## ***Vertex System Technical Service Bulletin 1***

### **Important update for systems sold prior to 05/07/2013**

**Optex Solar Pty. Ltd.**  
www.EcoOnline.com.au  
email: [info@EcoOnline.com.au](mailto:info@EcoOnline.com.au)

## 1.2 Collector Contraction Issue (Level of Importance: HIGH)

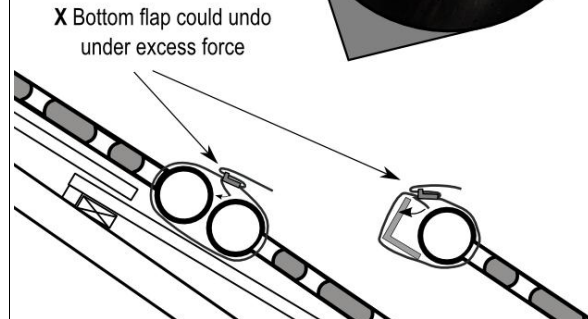
We recently found that collectors can contract by up to 10mm in length; this is on top the thermal contraction. We recommend straps be checked the next time you service your system. If the top strap seems too tight they may need to be loosened to allow for thermal contraction. **This check should be carried out while the panels are cool.**
